Re: Willbridge Bulk Fuels Area Project  
Consent Order

In the Matter of: )  
 ) DEQ No. WMCSR-NWR-94-06  
CHEVRON U.S.A. PRODUCTS COMPANY, )  
SHELL OIL COMPANY, and UNION OIL ) ORDER ON CONSENT  
COMPANY OF CALIFORNIA, )  
 )  
Respondents. )

Conceptual Site Model - Current Conditions  
Willbridge Facility Risk Assessment  
Willbridge Terminal Group, Portland, Oregon

FIG 37

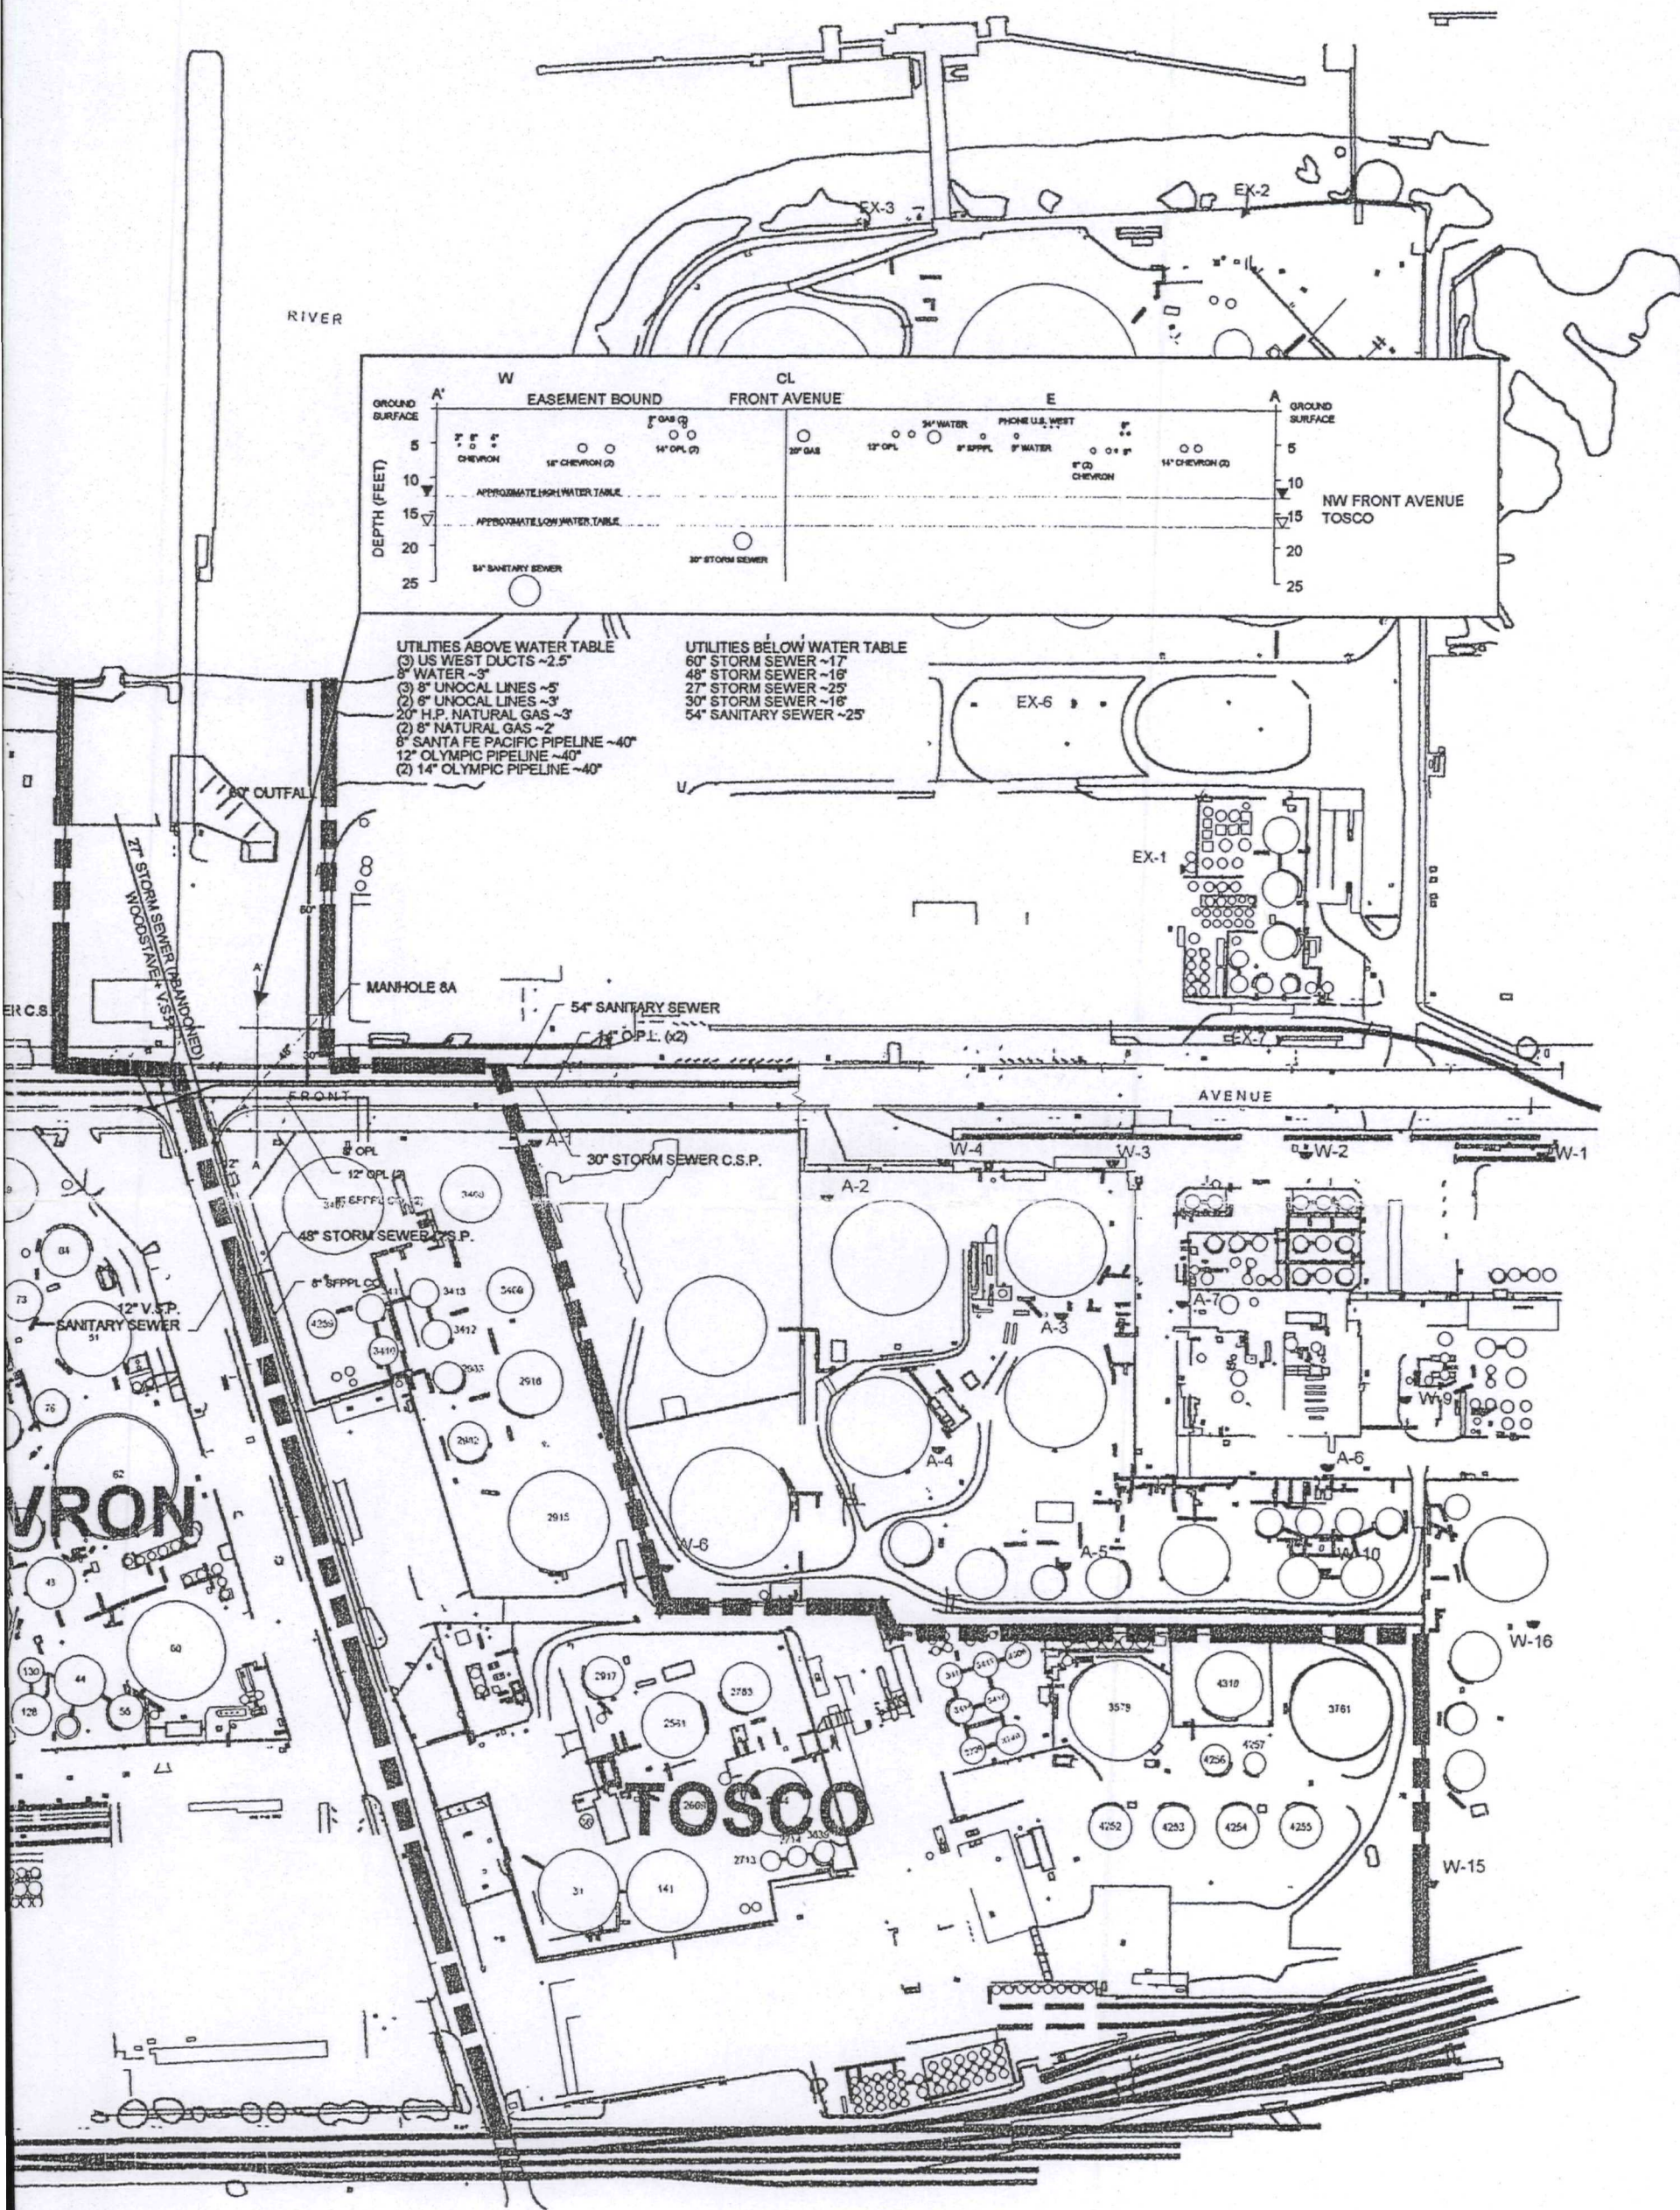
33. Section 5.3.1.3. The purpose of the utility trench investigation should be stated. Also, in Figure 37, the cross-section inserts are unreadable. A more legible copy of this figure should be provided in the revised report.

Conceptual Site Model (Attachments A & B): Based on Figure 37 of the Draft Remedial Investigation Report, two storm sewers and one sanitary sewer are at elevations below the water table. As such utility workers are likely to be exposed to contaminants in groundwater. The CSM should identify groundwater ingestion, vapor inhalation, and dermal contact as potential exposure pathways for the utility workers. Subsequently, the baseline human health risk assessment should evaluate these exposure scenarios as appropriate.

33. Section 5.3.1.3 will be revised. The purpose of the utility trench investigation will be clearly stated. In addition, Figure 37 will be re-drafted to provide a more legible map.

Copies	Description
<u>3</u>	<u>Revised Figure 37 for the Remedial Investigation at the Willbridge Facility</u>
